# URBAN DESIGN COMMITTEE

## URBAN DESIGN COMMITTEE STAFF REPORT

APPLICATION NUMBER	Urban Design Record #22137
APPLICATION TYPE	Advisory Review
ADDRESS/LOCATION	Northeast corner of NW 48 <sup>th</sup> and W Holdrege Street
HEARING DATE	January 3, 2023
ADDITIONAL MEETINGS	N/A
APPLICANT	Derek Zimmerman, <a href="mailto:derek@revdev.com">derek@revdev.com</a>
STAFF CONTACT	Collin Christopher, 402-441-6370, <a href="mailto:cchristopher@lincoln.ne.gov">cchristopher@lincoln.ne.gov</a>

APPLICATION NUMBER	Urban Design Record #22138
APPLICATION TYPE	Advisory Review
ADDRESS/LOCATION	2716 and 2718 Starr Street (N 27 <sup>th</sup> and Starr Streets)
HEARING DATE	January 3, 2023
ADDITIONAL MEETINGS	N/A
APPLICANT	Aaron Burd, <a href="mailto:amburd76@gmail.com">amburd76@gmail.com</a>
STAFF CONTACT	Collin Christopher, 402-441-6370, <a href="mailto:cchristopher@lincoln.ne.gov">cchristopher@lincoln.ne.gov</a>

## 7.1 Parking Lots, Parking Areas, and Driving Aisles

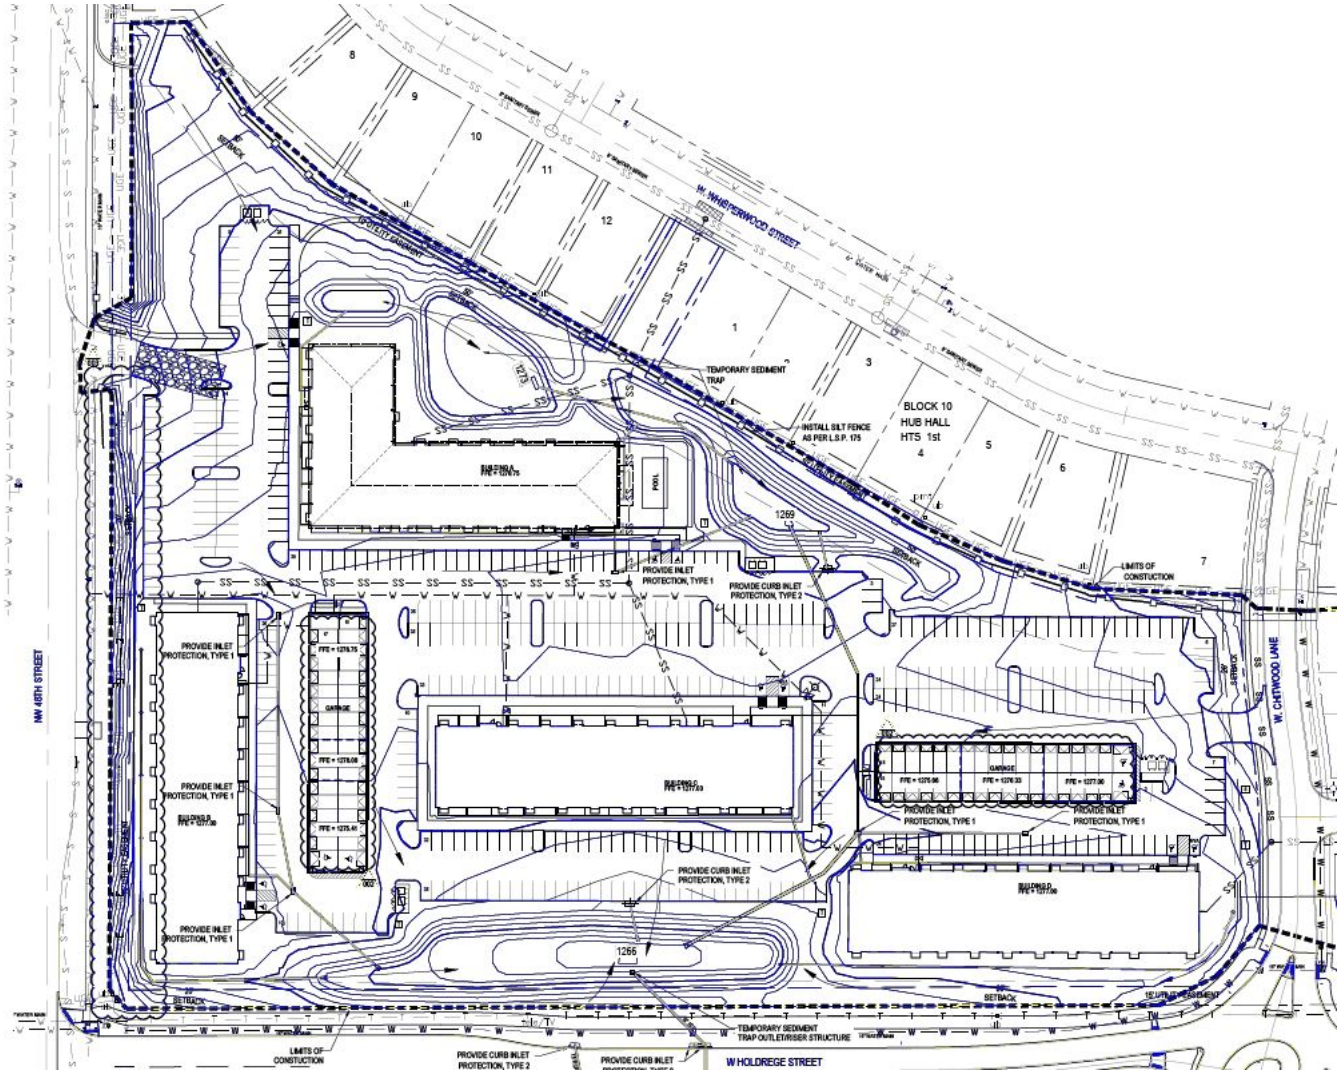
**Compatibility per Staff Analysis:** The parking lot shown in the renderings does not appear to fully meet the above standards.

**LANDSCAPING PLAN**  
 SCALE: 1" = 20'-0"

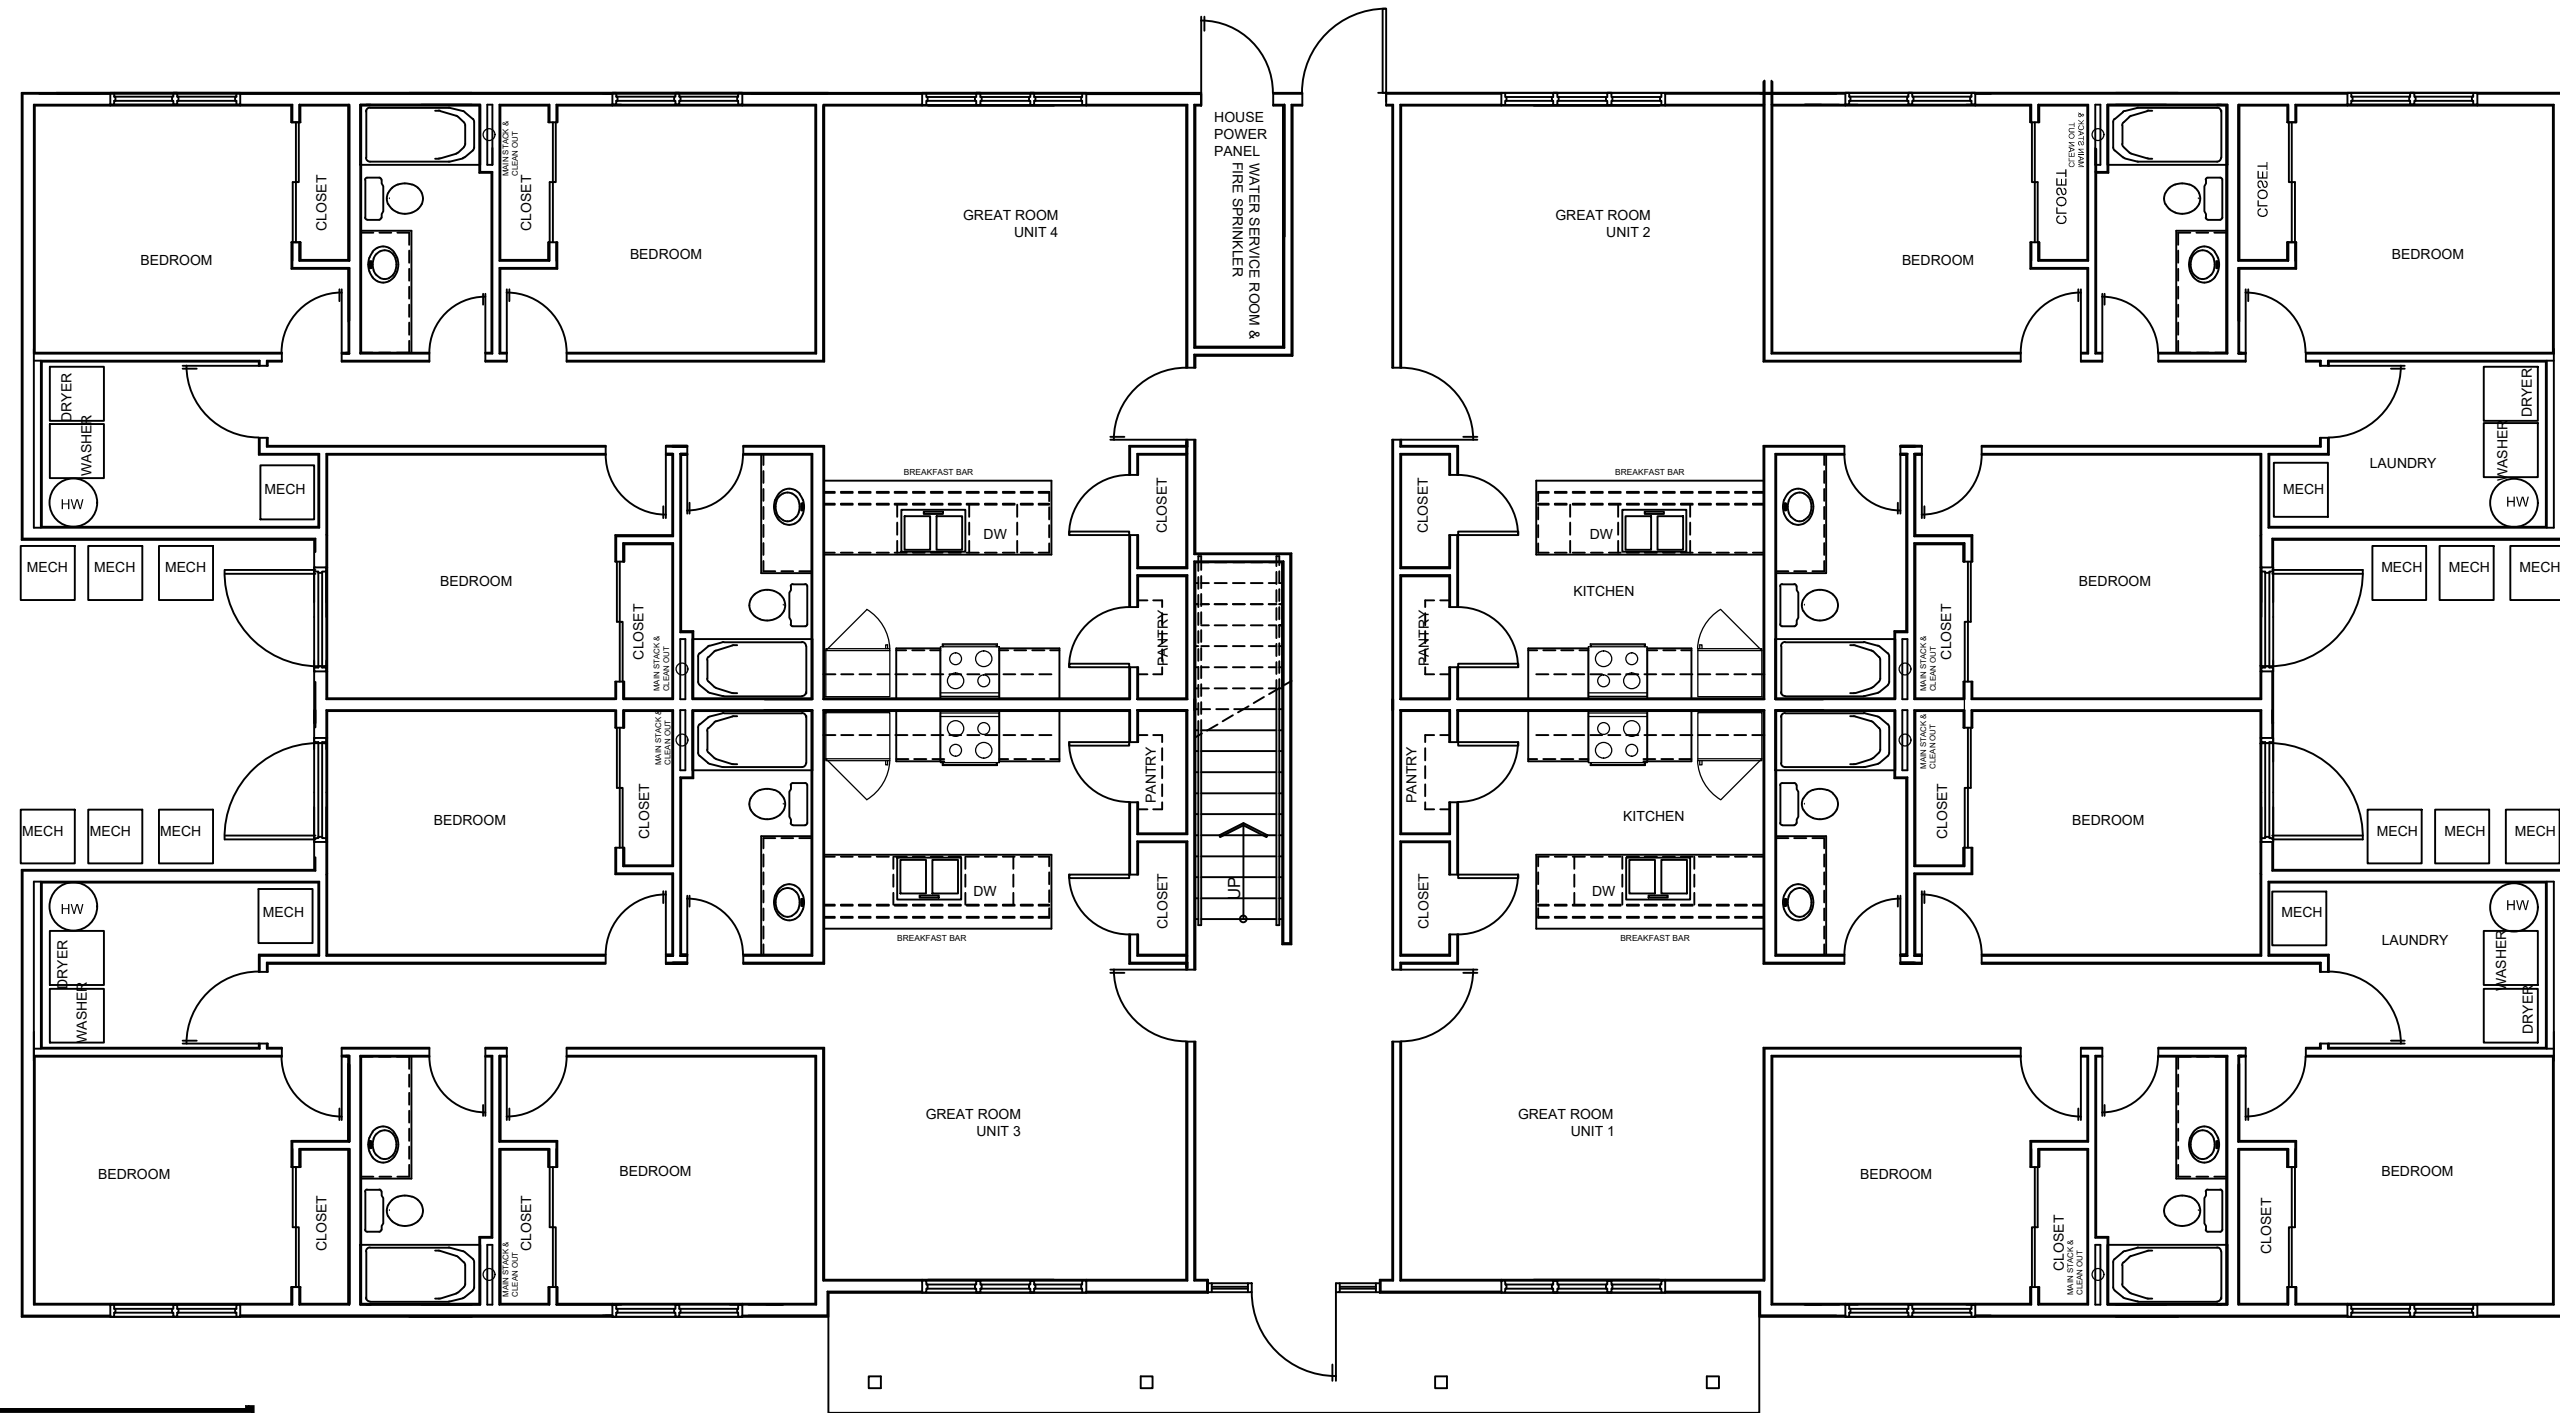
**Compatibility per Staff Analysis:** Only two of the three required trees are being shown in the parking lot for the 12-plex. The tri-plex shows a total of six stalls, which would typically require one tree. However, the property is being replatted so that each unit sits on its own property. In that scenario, each property would only have two parking stalls and would not be subject to this standard.

**Compatibility per Staff Analysis:** While this standard is somewhat vague in regards to screening of parking lots, the Design Standards for Screening and Landscaping for which this property is also subject to will require that the entire length of the north edge of the parking lot for the 12-plex (adjacent to the alley) be screened up to three feet (3') in height. Again, the requirements for the tri-plex come down to whether this would be considered a single parking lot of six stalls or three parking lots of two stalls each. For the former, a screen would be required along the east edge to provide a buffer against the adjacent residential.

TRI-PLEX NORTH ELEVATION

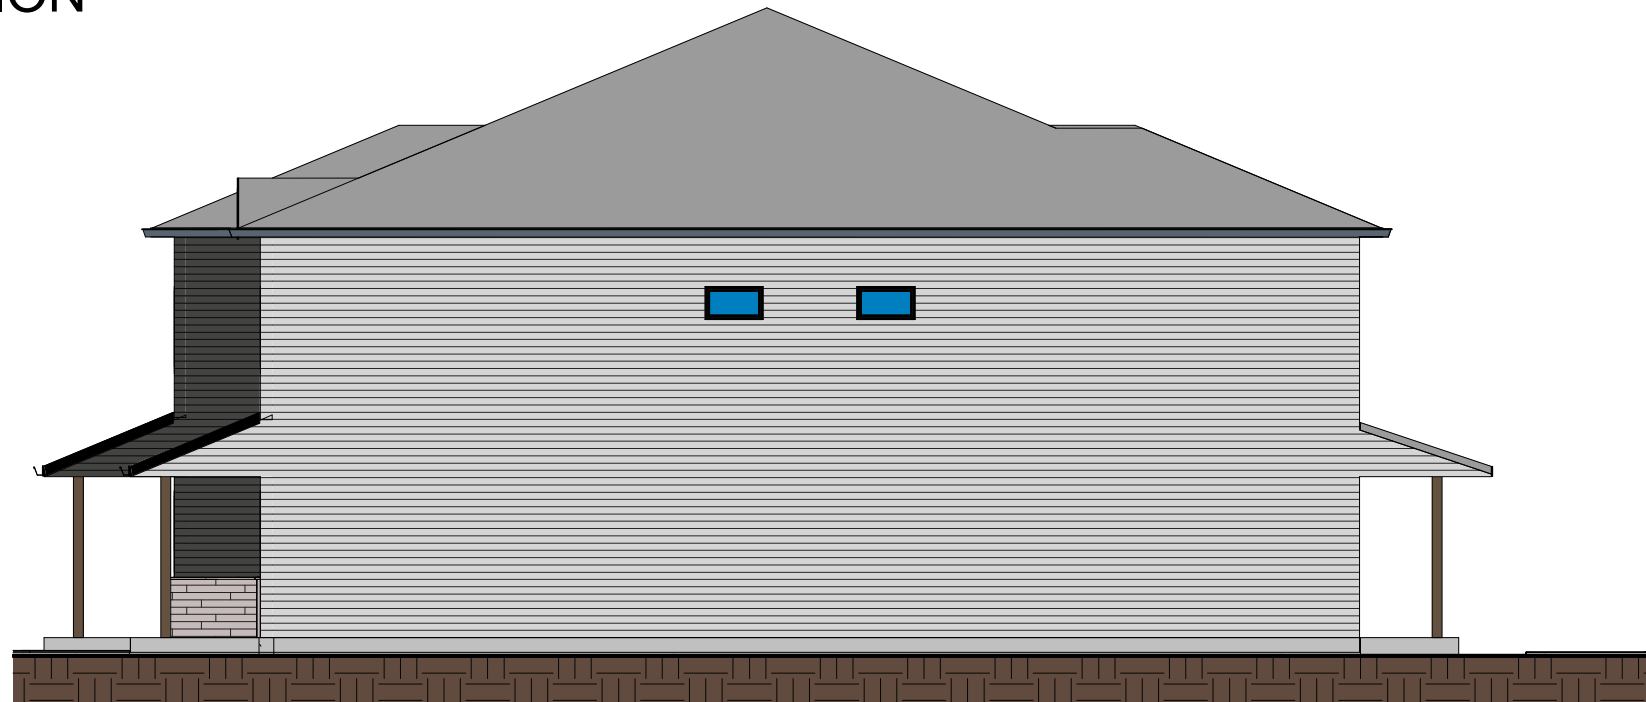
**Compatibility per Staff Analysis:** The three-story 12-plex is facing one-story commercial buildings and is okay from a compatibility perspective. The two-story tri-plex sits adjacent to one and one-and-a-half story homes. The steepness of the roof of the tri-plex also adds to the difference in heights, making it questionable whether this particular standard is being met.
